Application for Planning Approval

DA2026/022

39A ANDREW STREET, BRIGHTON

MULTIPLE DWELLINGS (1 EXISTING, 34 NEW) & ASSOCIATED INFRASTRUCTURE

DRAWING TITLE:
COVER & EXISTING & DEMOLITION
PLAN

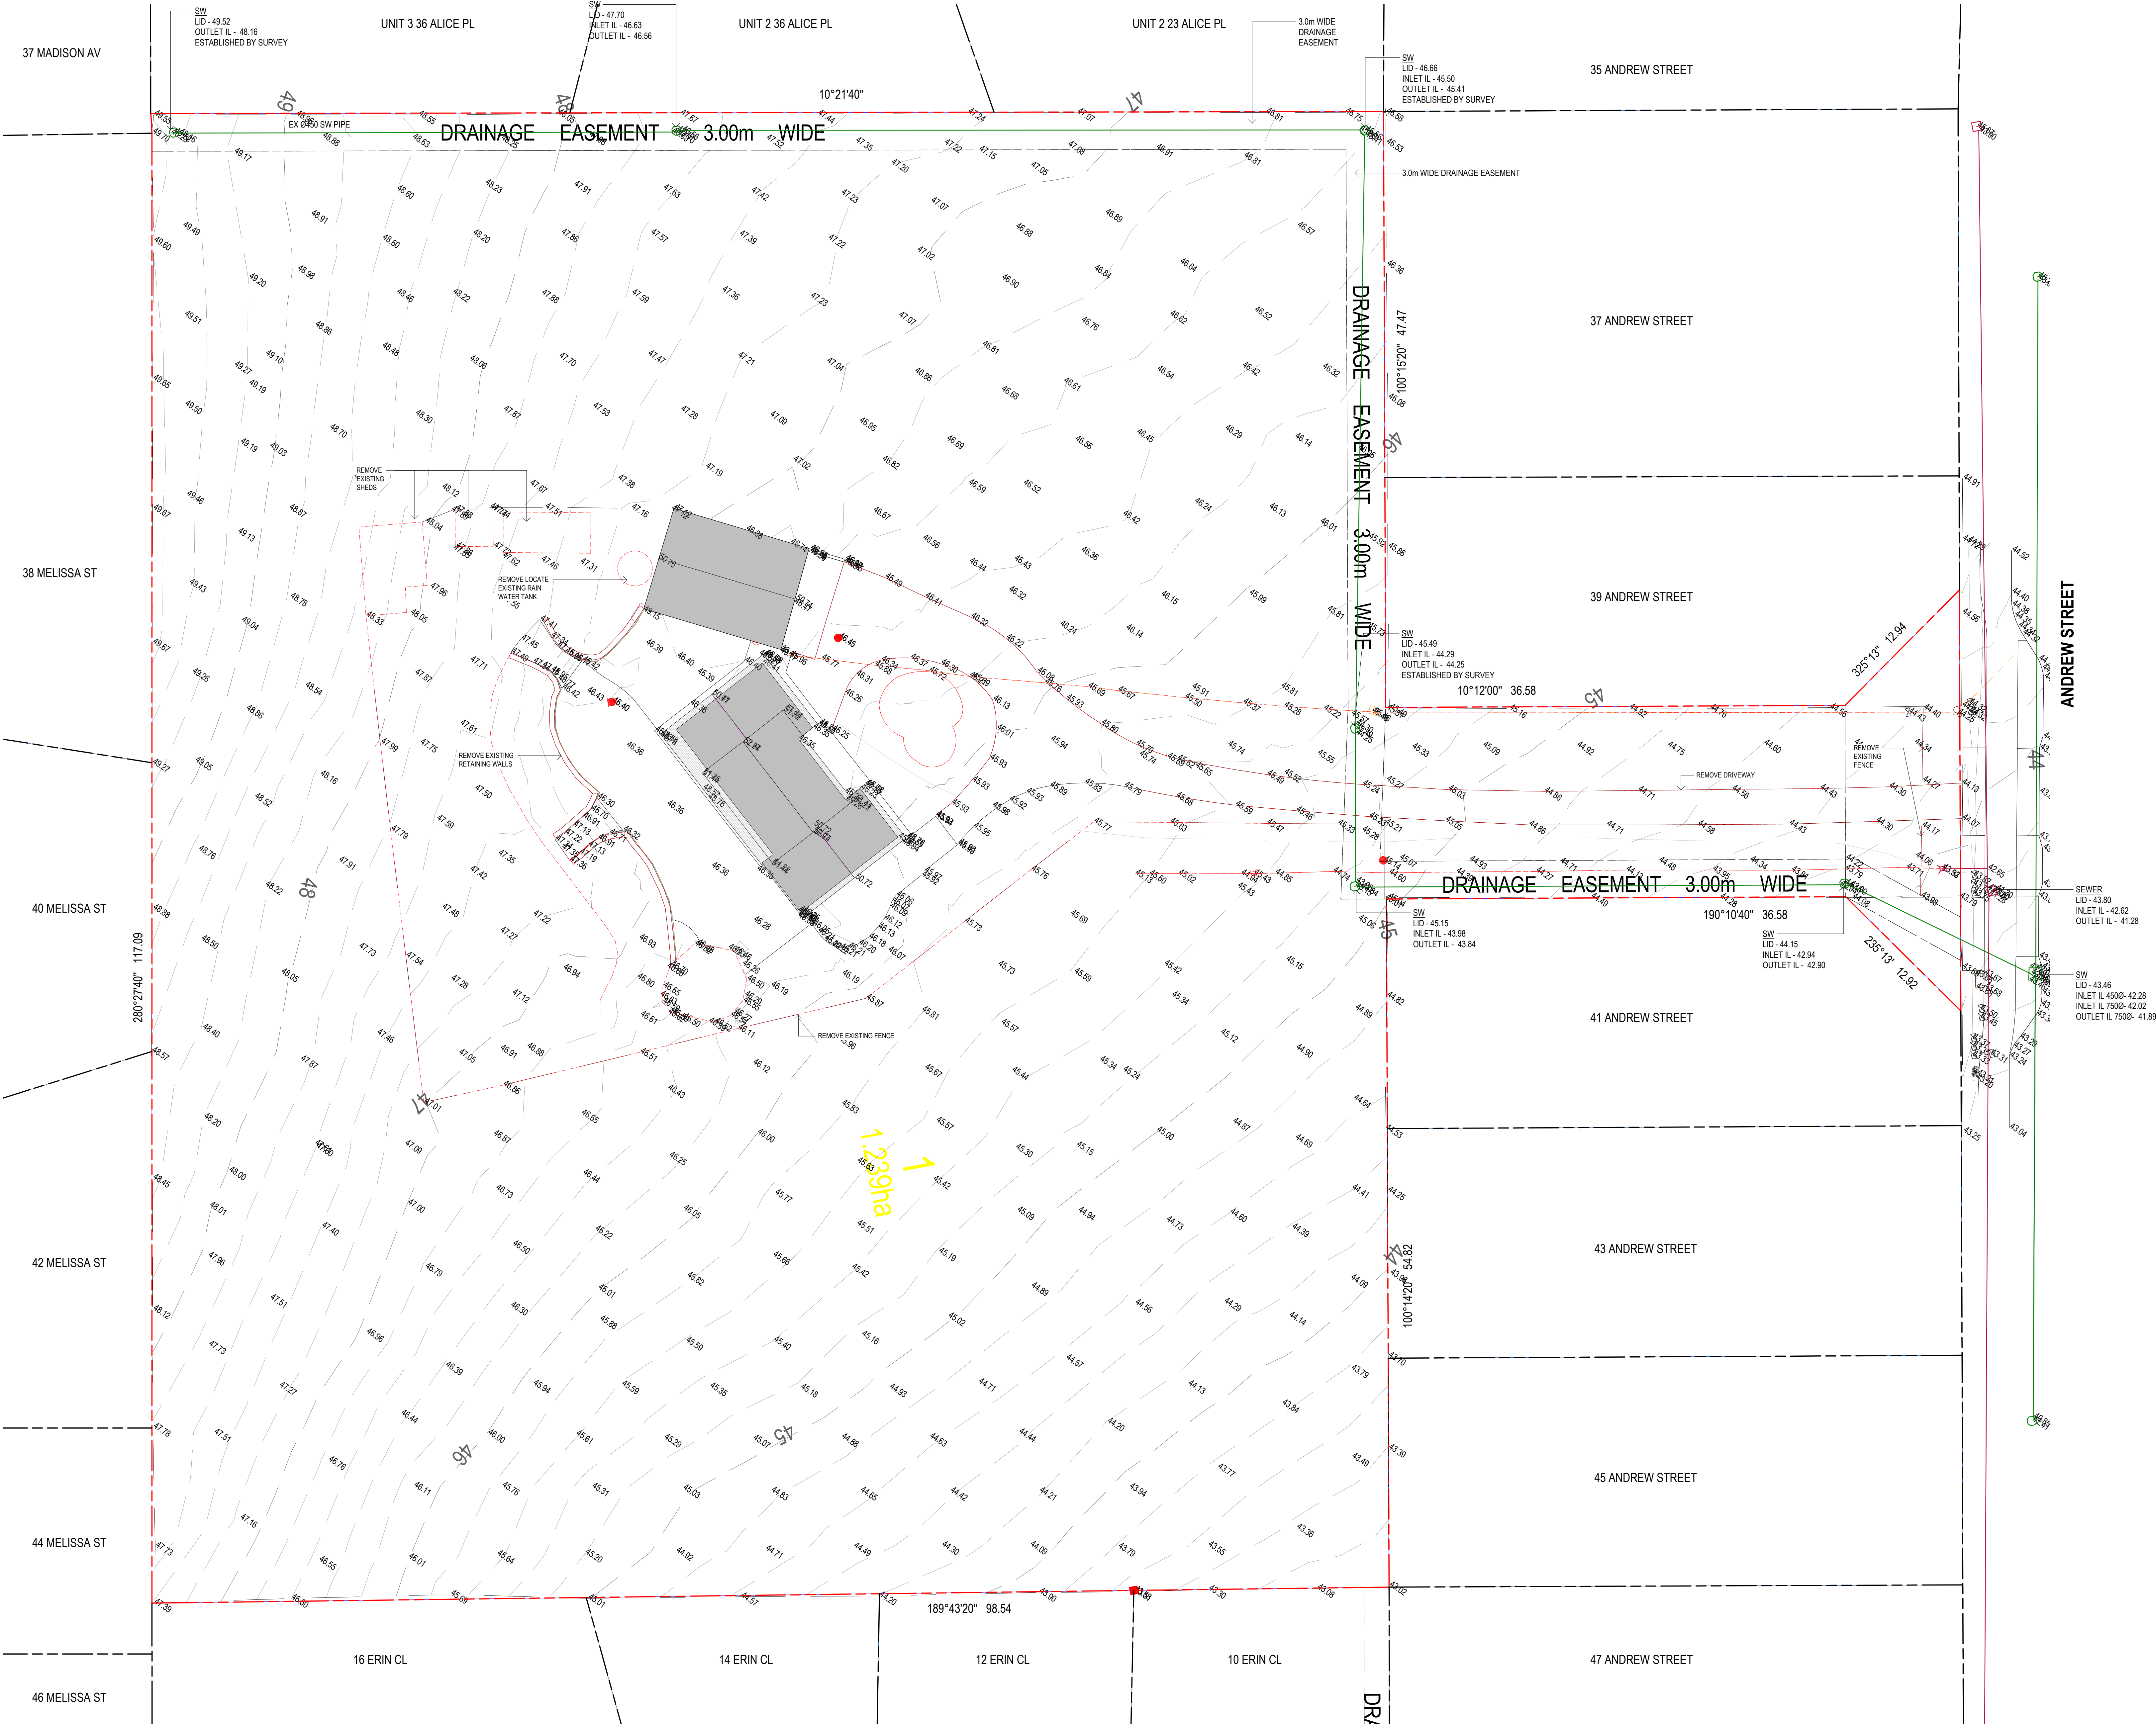
Floor area of each dwelling (8.4.3 A1(a)) **Refer drawing DA01 for the floor area schedule**

DRAWING TITLE:
SUN SHADOW DIAGRAMS

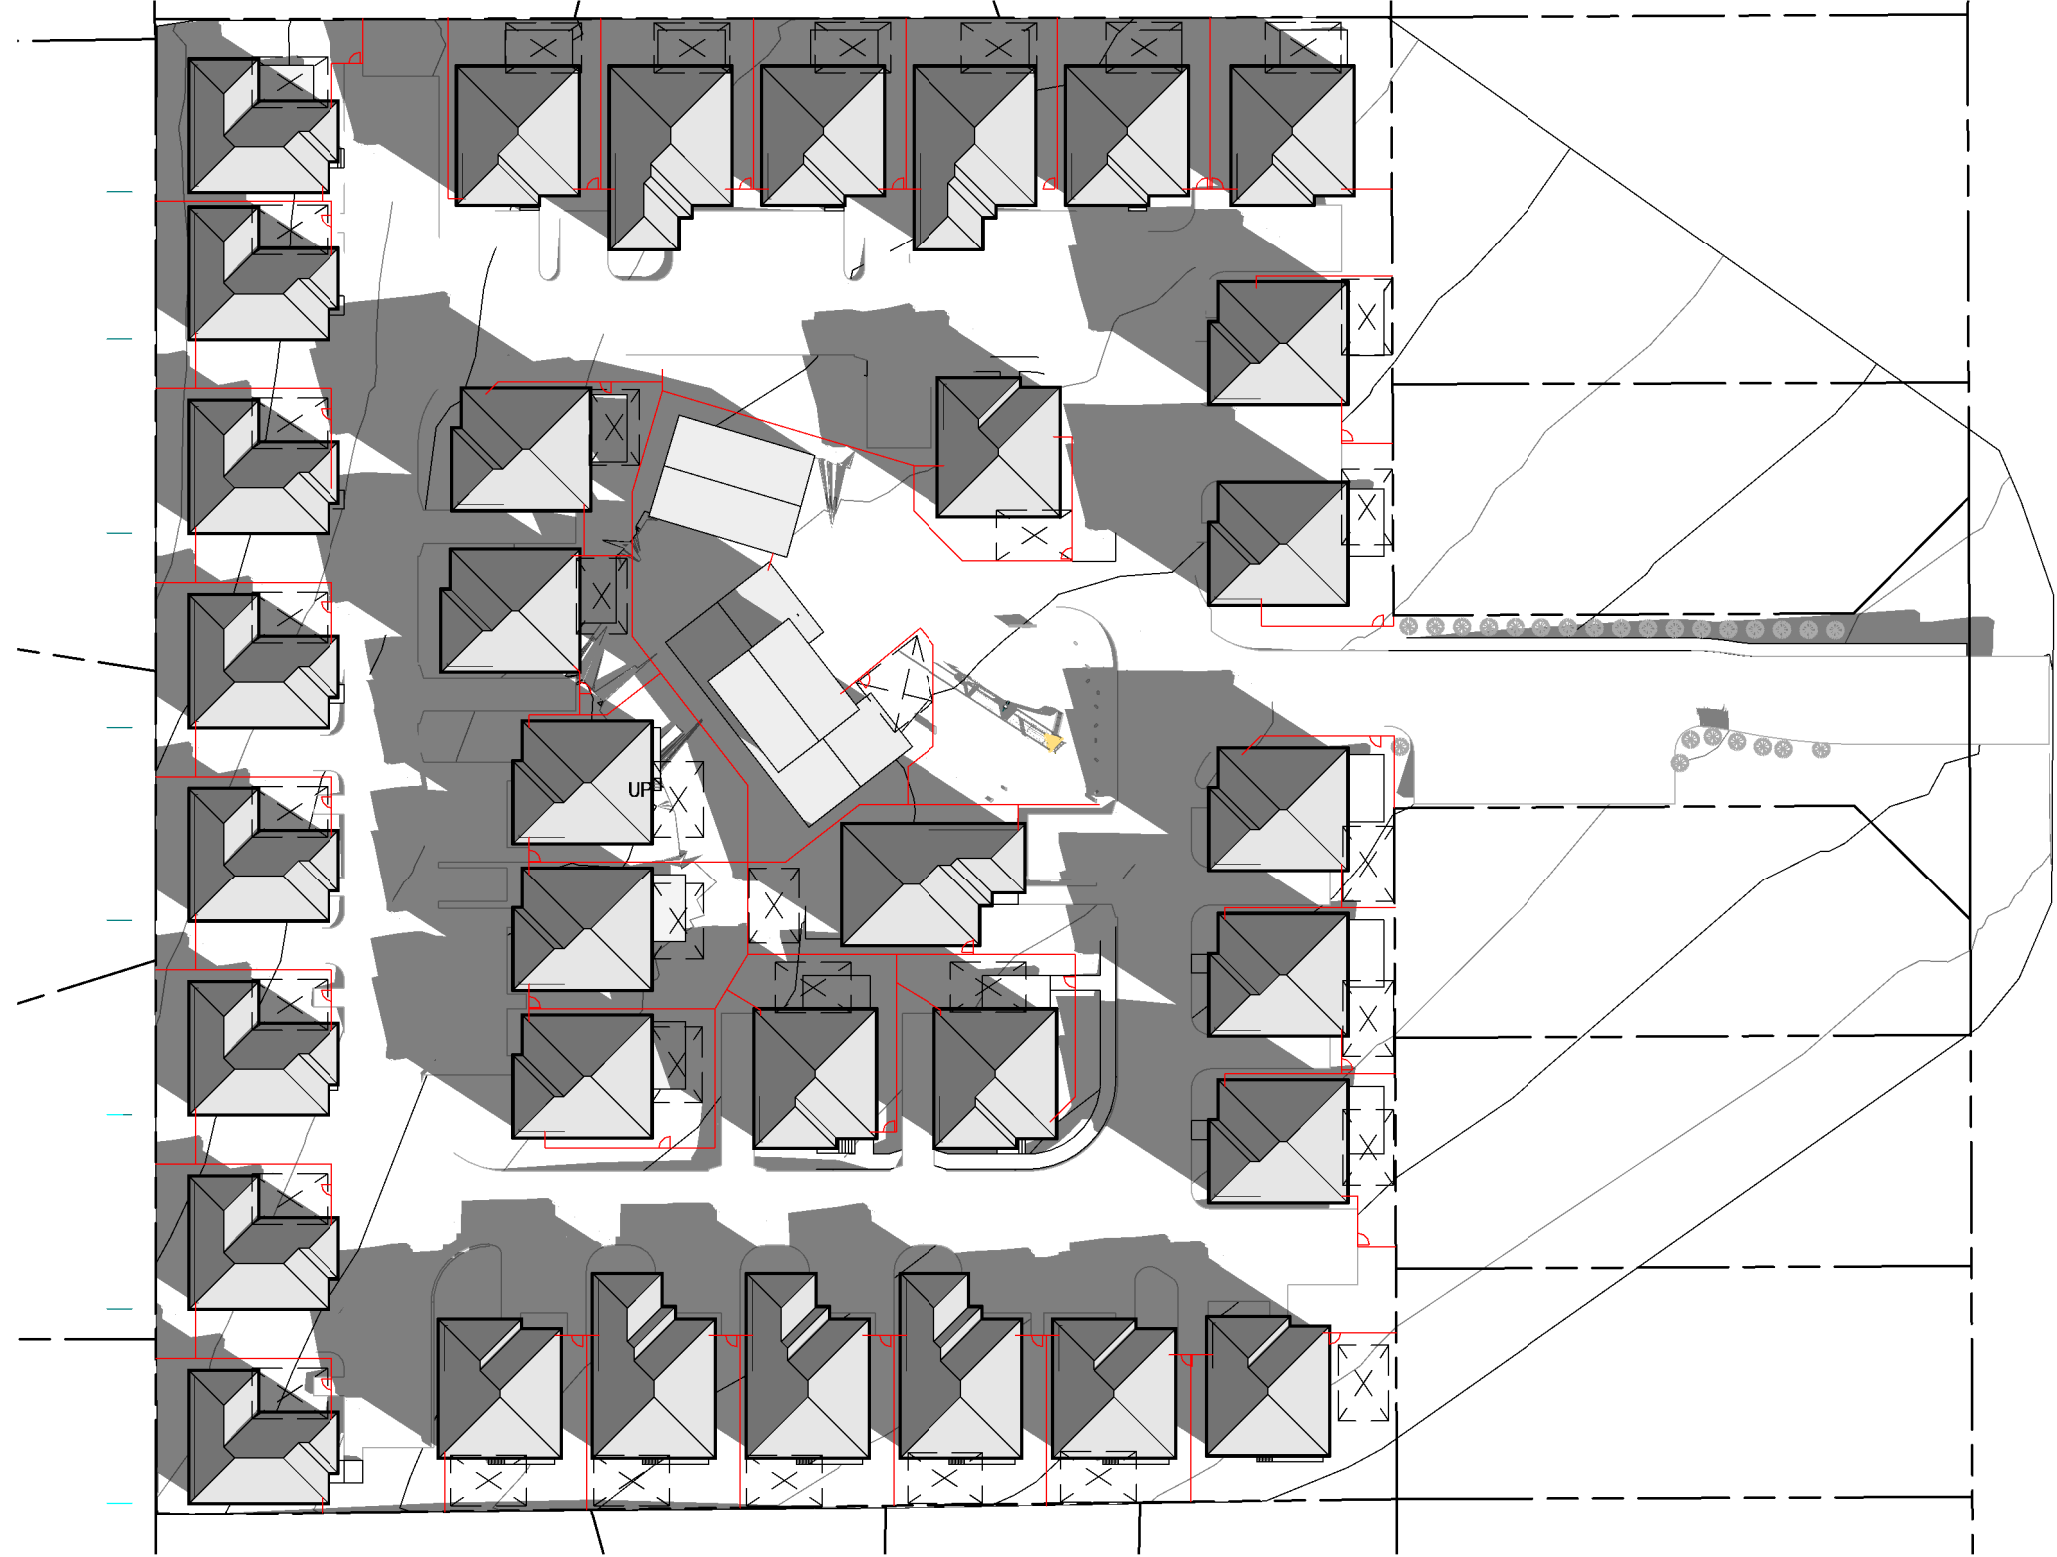
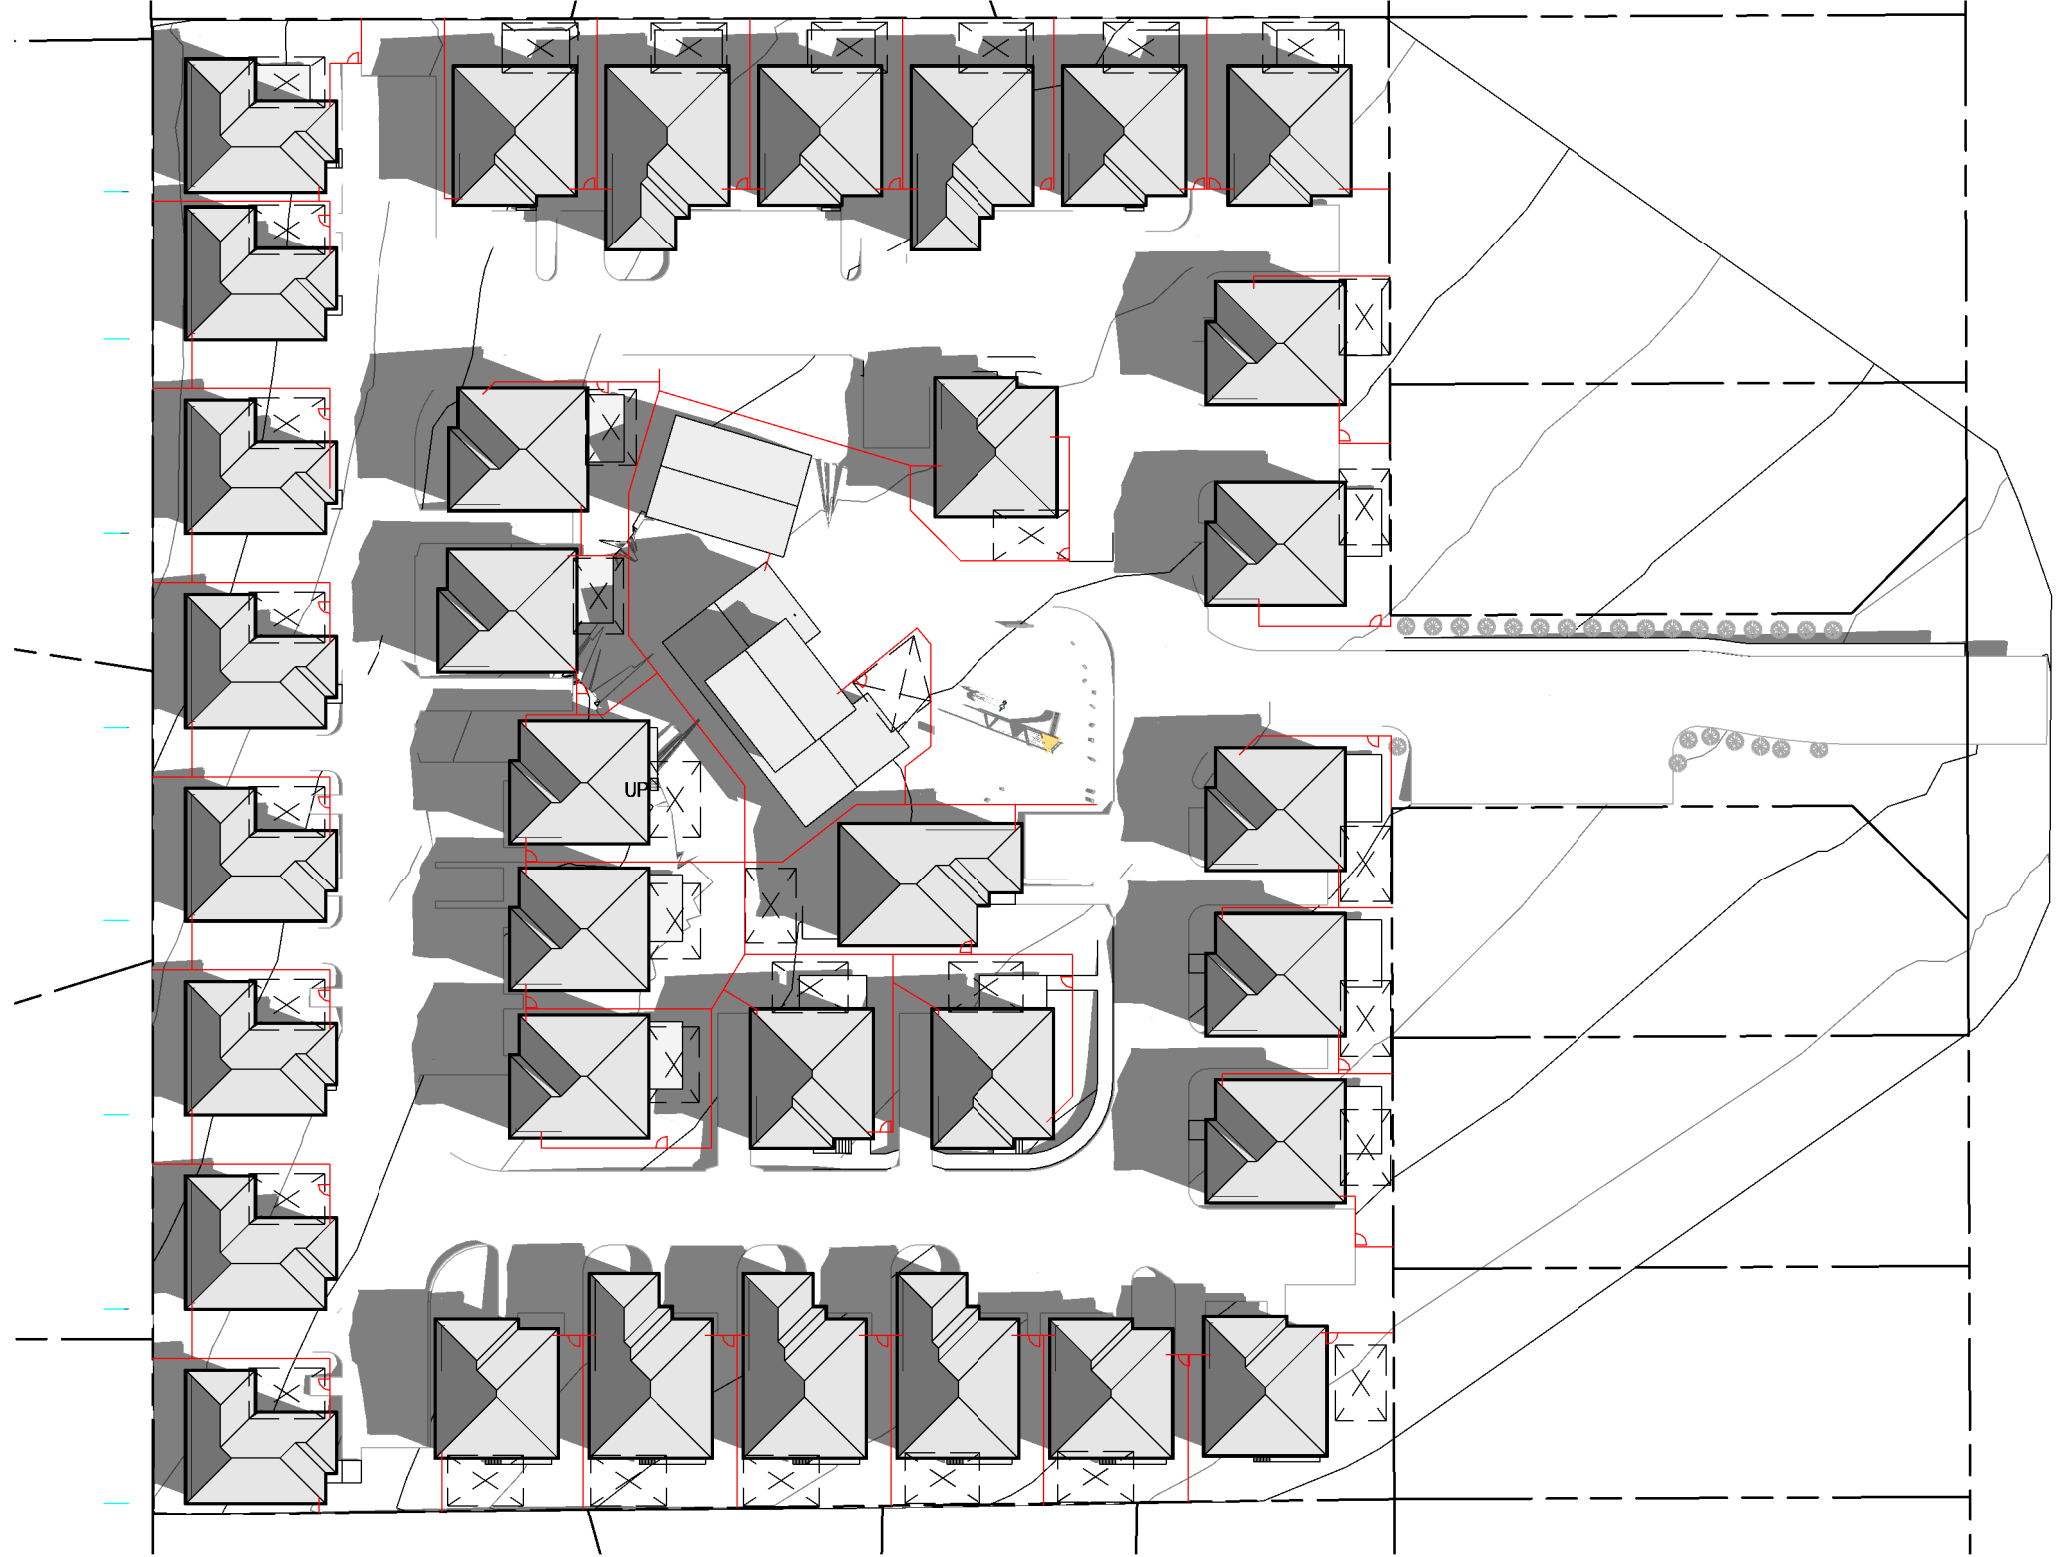
Please provide a planning report addressing each of the development standards, and where the proposed application does not satisfy the acceptable solution (eg 8.4.2 A1; 8.4.2 A3; 8.4.4 A1), include a written response to the performance criteria.

8.4.4 – A1 – The shadow diagrams provided in Drawing DA20 demonstrate that all proposed units (POS) will receive a minimum of 3 hours of direct sunlight between 9:00 am and 3:00 pm on 21 June. Accordingly, the proposed development satisfies the requirements of Acceptable Solution 8.4.4–A1(b).
